AEP:NRC:3054-06
10 CFR 2.202

Donald C. Cook Nuclear Plant Unit 1 and Unit 2
RESPONSE TO REQUEST FOR ADDITIONAL INFORMATION
REGARDING RELAXATION OF REACTOR PRESSURE VESSEL HEAD
PENETRATION INSPECTION REQUIREMENTS IN NUCLEAR
REGULATORY COMMISSION ORDER

ATTACHMENT 1 TO AEP:NRC:3054-06

RESPONSE TO REQUEST FOR ADDITIONAL INFORMATION

Sketch of D.C. Cook Unit 1 and Unit 2 Reactor Vessel Head Penetration
(Not to Scale)

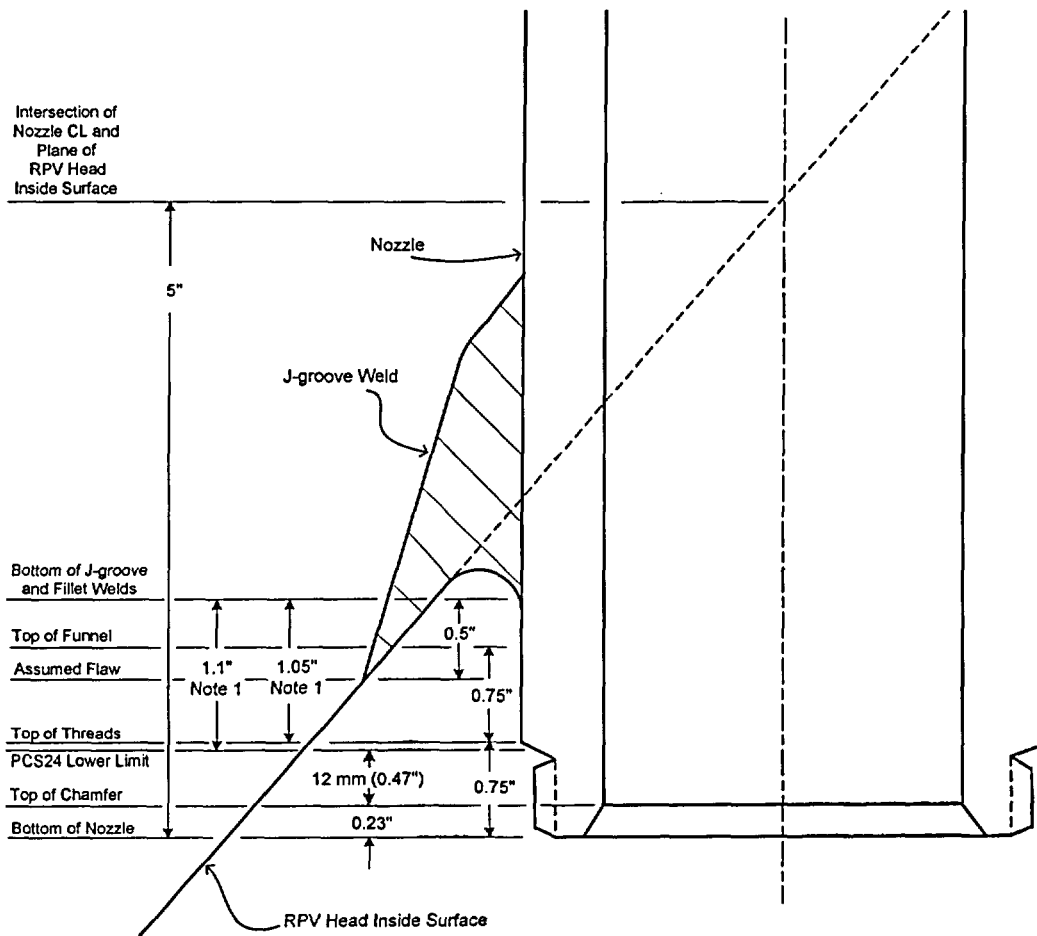
The licensee stated that a small portion of base material will not be scanned on the bottom of the nozzle because the lower transducer and the upper transducer of the probe need to be in contact with the nozzle material. The distance from the bottom of the nozzle upward that cannot be scanned is 12 mm. Please identify the minimum distance from the J-groove weld to the location on the nozzle that cannot be scanned.

The licensee is requested to provide a sketch of the nozzle with the necessary dimensioning to clarify the areas covered by the request.

Provide the distance from the bottom of the weld to the point where ET/PT cannot be performed.

As shown in the sketch provided at the end of this attachment, the distance from the bottom of the nozzle upward that cannot be scanned due to the PCS24 probe transducer arrangement has been calculated to be 12 millimeters (0.47 inches) plus the height of the chamfer (0.23 inches). The minimum distance downward from the J-groove weld to the location on the nozzle that cannot be ultrasonically scanned due to the PCS24 probe transducer arrangement has been calculated to be 1.1 inches. Due to the curvature of the RPV head, this minimum distance only occurs at one point on the downhill side of the outermost penetrations (six penetrations on Unit 1 and five penetrations on Unit 2).

A sketch has been provided at the end of this attachment.

The nozzles that have guide funnels installed are the outermost nozzles. As shown in the sketch provided with this attachment, the guide funnels extend approximately 0.75 inches above the threads. Consequently, the minimum distance from the J-groove weld to the location on the nozzle that cannot be examined by eddy current testing or dye penetrant testing on nozzles that have funnels installed is less than the distance assumed in the crack growth calculation described

GRAPHS OF STRESS VERSUS DISTANCE BELOW J-GROOVE WELD

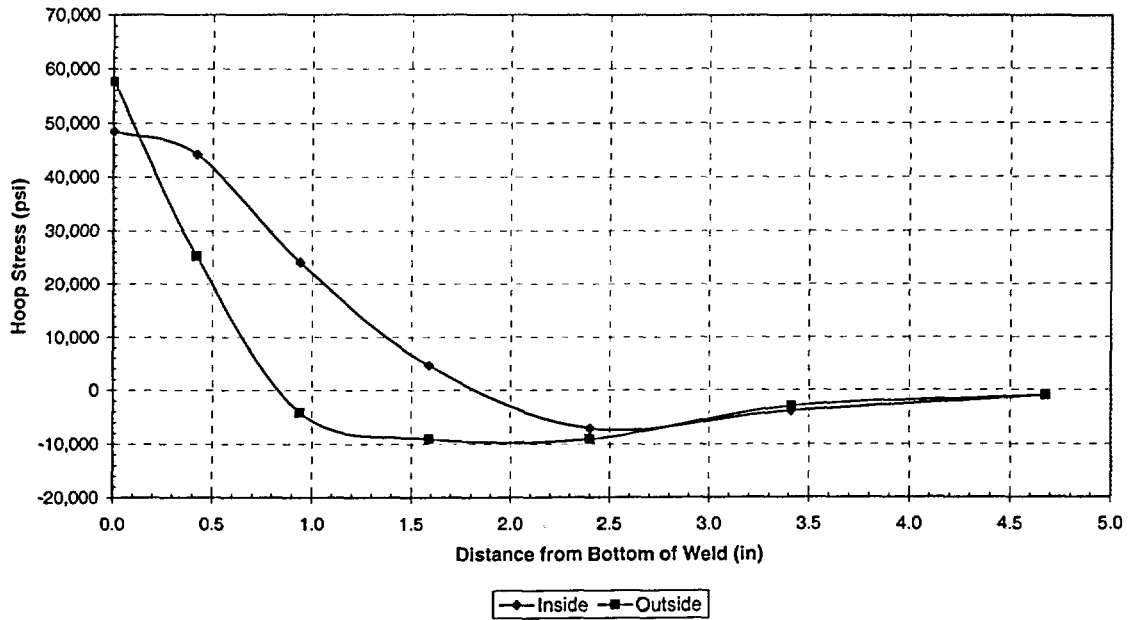
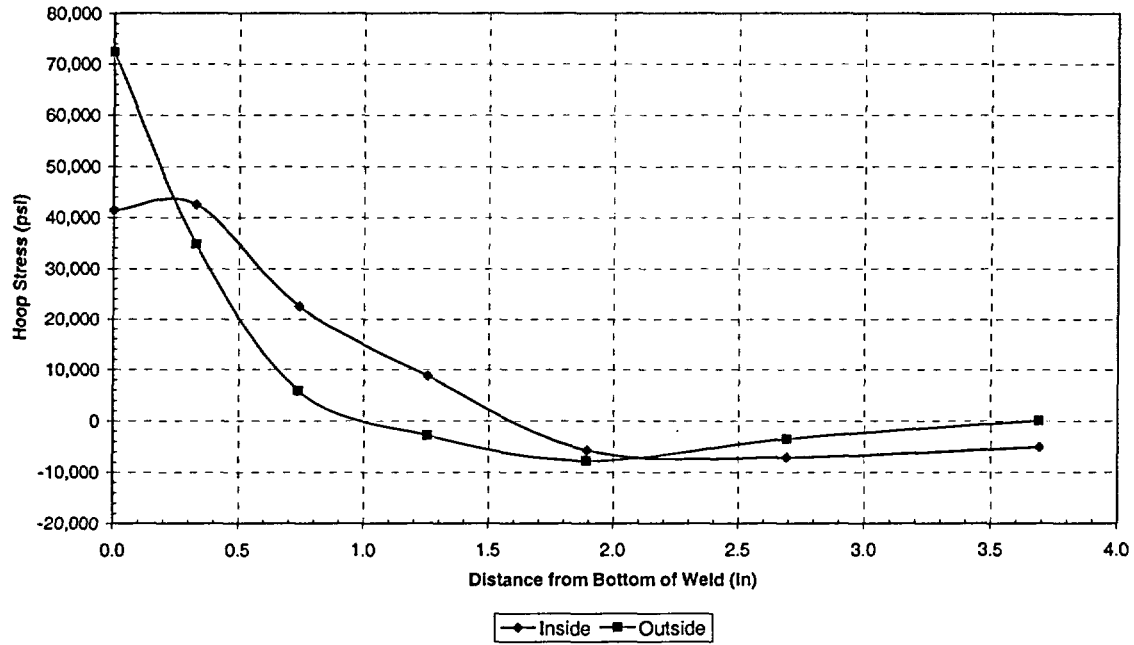
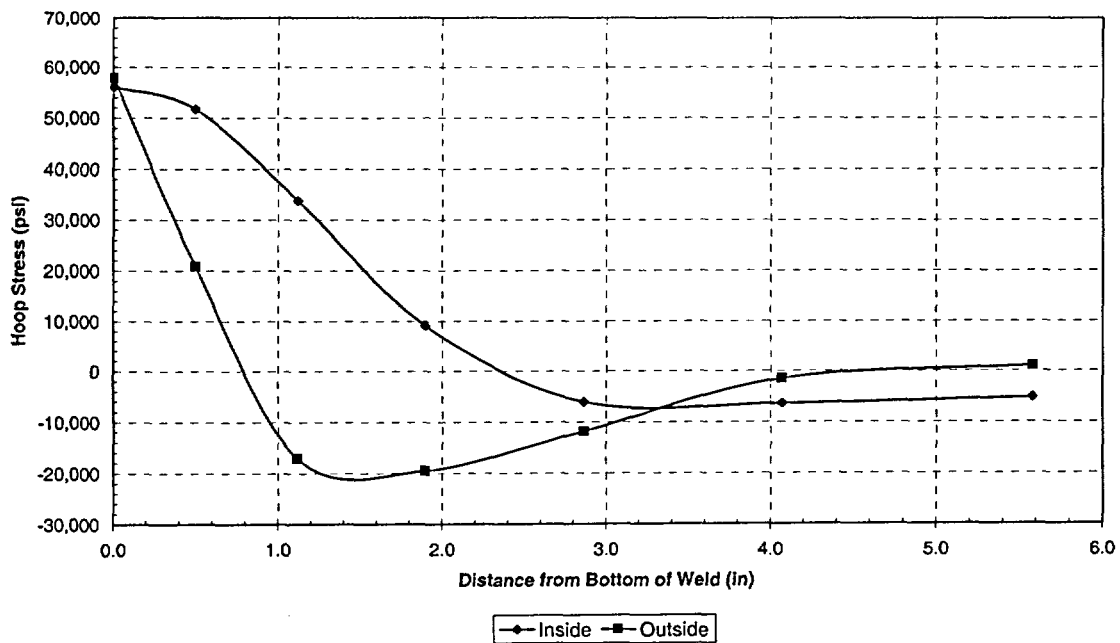
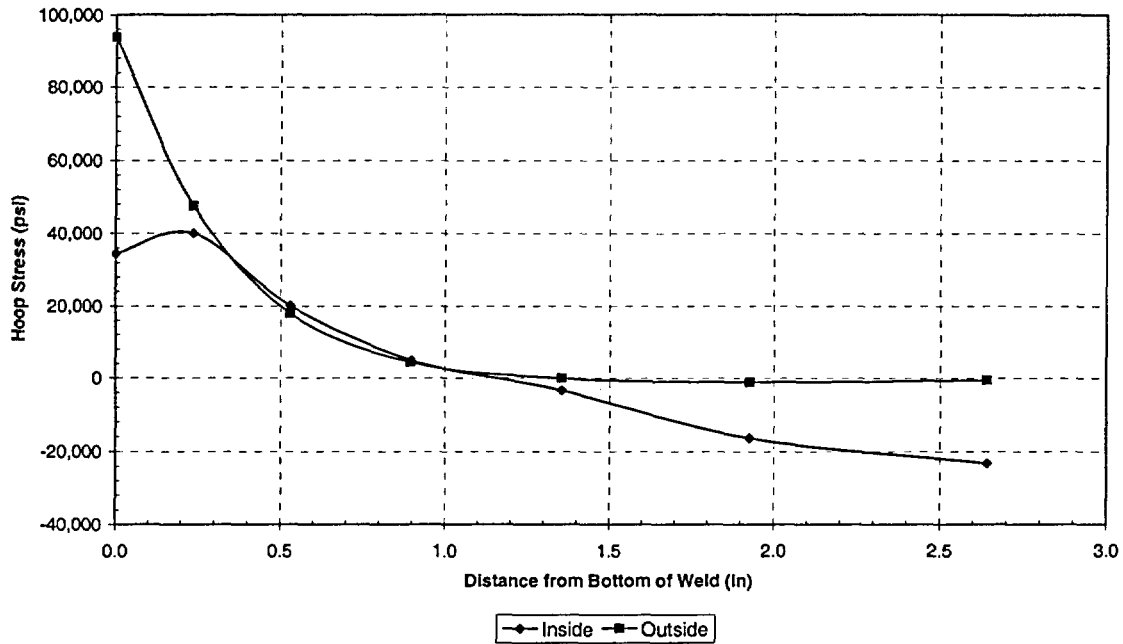
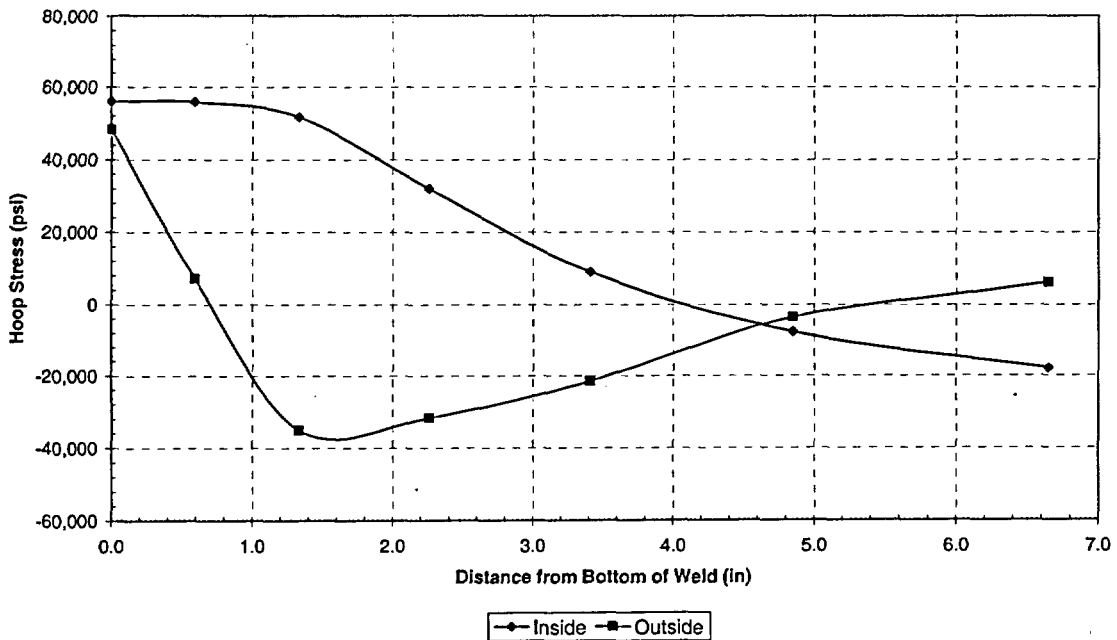
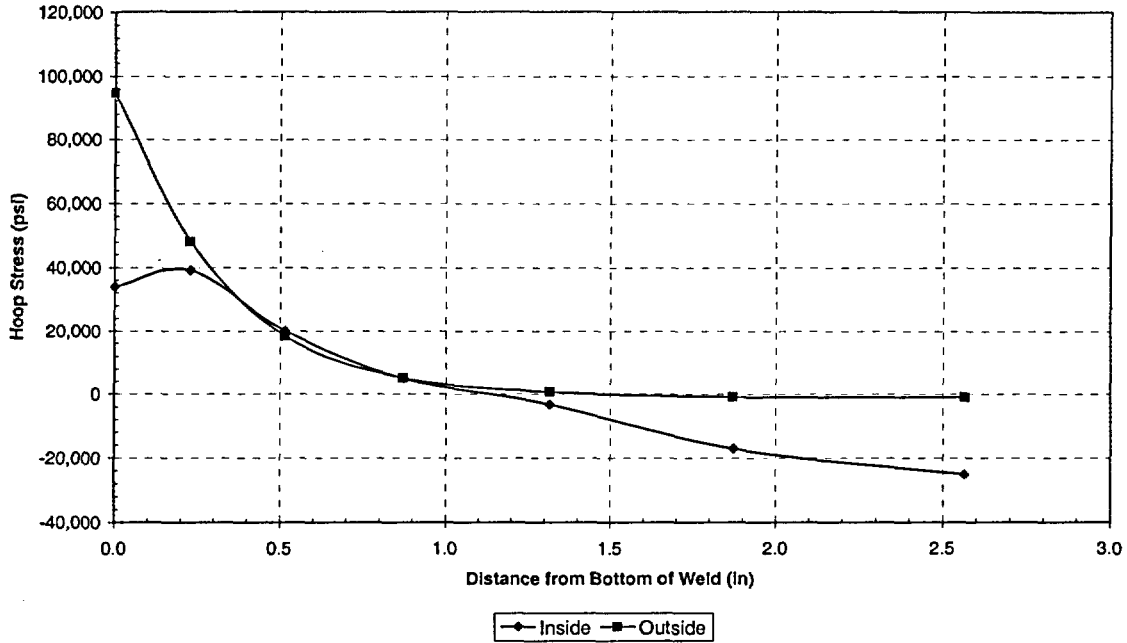
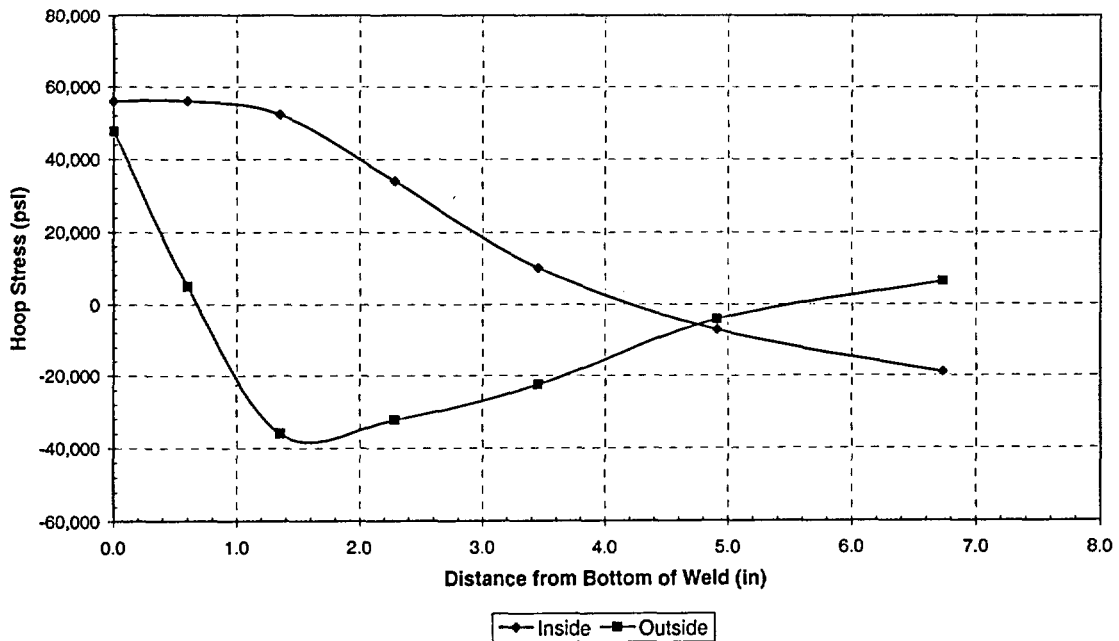
Provide additional technical justification (i.e., operating stress levels, crack growth analysis, etc.) that supports the licensee's statement that the small area that cannot be scanned is insignificant to the phenomena of concern.

The operating stresses in that area are shown in Attachment 2 to this letter, which provides graphs of hoop stress versus distance below the J-groove weld for various nozzles from the center of the Unit 2 RPV head to the outermost row. As shown in these graphs, the stresses in the area of the nozzle that would not be inspected are low relative to the yield stress of the nozzle material (41,000 to 63,000 pounds per square inch).

**Hoop Stress Distribution Below the Weld Downhill Side
(50.5° CRDM Penetration Nozzle)**

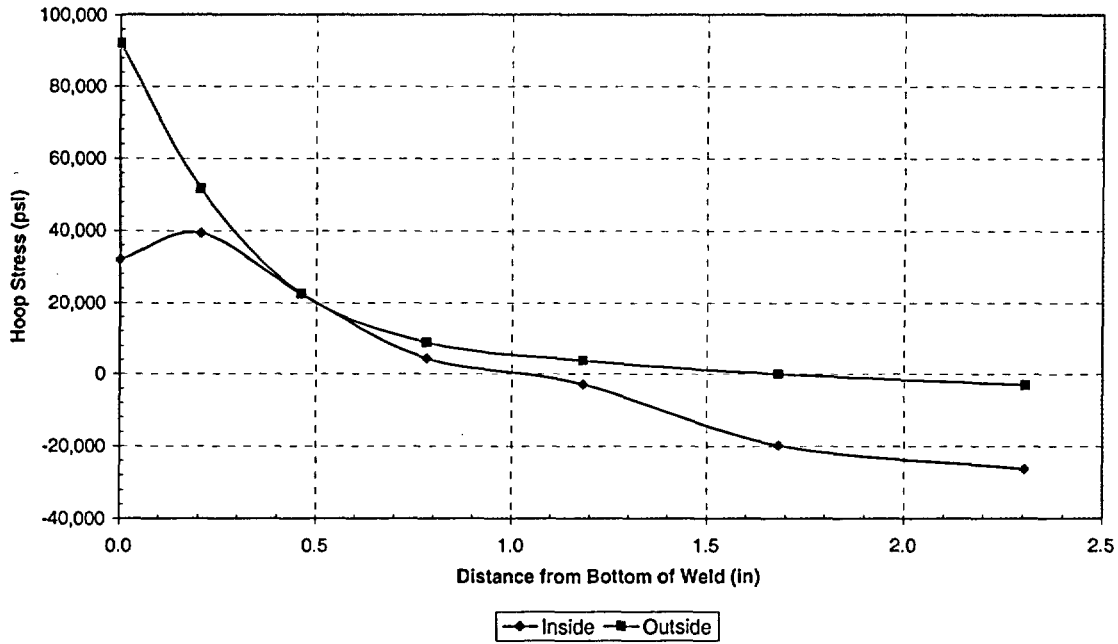
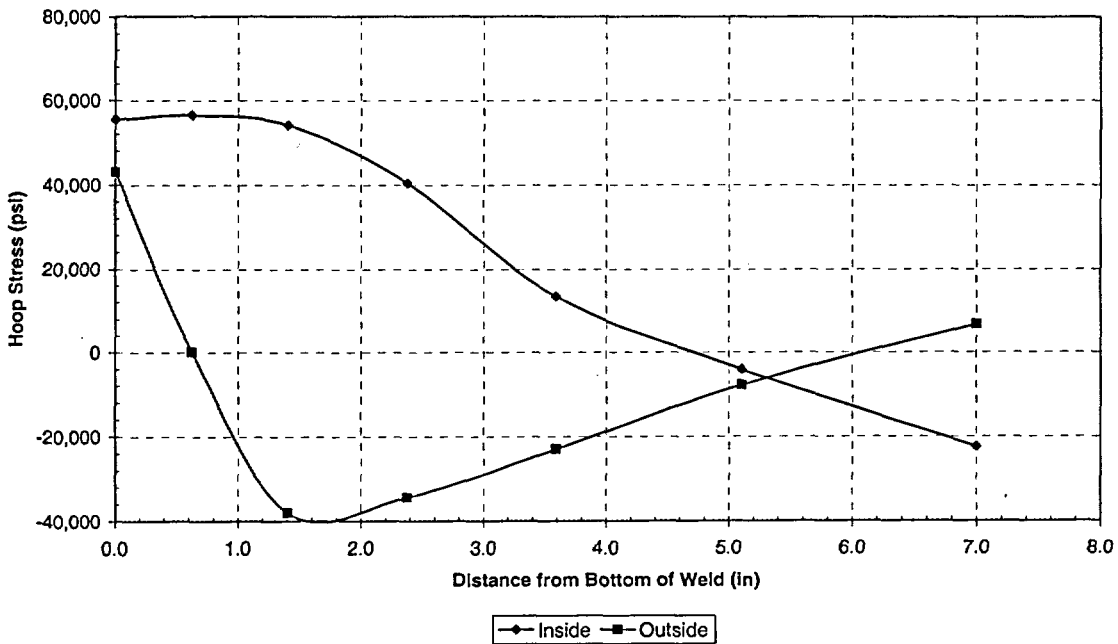
The licensee stated that at least five nozzles are threaded approximately 0.75 inches at the bottom of the nozzle. Provide the distance from the bottom of the weld to the threaded area that cannot be examined by UT. Additionally, please provide a more exact count of the nozzles that would be affected.

The minimum distance from the J-groove weld to the threaded area has been calculated to be 1.05 inches. Due to the curvature of the RPV head, this minimum distance only occurs at one point on the downhill side of the outermost penetrations (labeled 50.5° in Attachment 2, six penetrations on Unit 1, five penetrations on Unit 2). The minimum distance from the J-groove weld to the threaded area for all other points on these penetrations, and for all points on the other 73 penetrations, exceeds this value. As indicated in the response to NRC Question 1 above, the minimum distance from the J-groove weld to the location on the nozzle that cannot be ultrasonically scanned due to the PCS24 probe transducer arrangement has been calculated to be 1.1 inches. Since this value is approximately equal to the 1.05 inch minimum distance to the threaded area, the minimum distance from the J-groove weld to the location on the nozzle that cannot be ultrasonically inspected due to both causes will be considered to be approximately 1 inch.
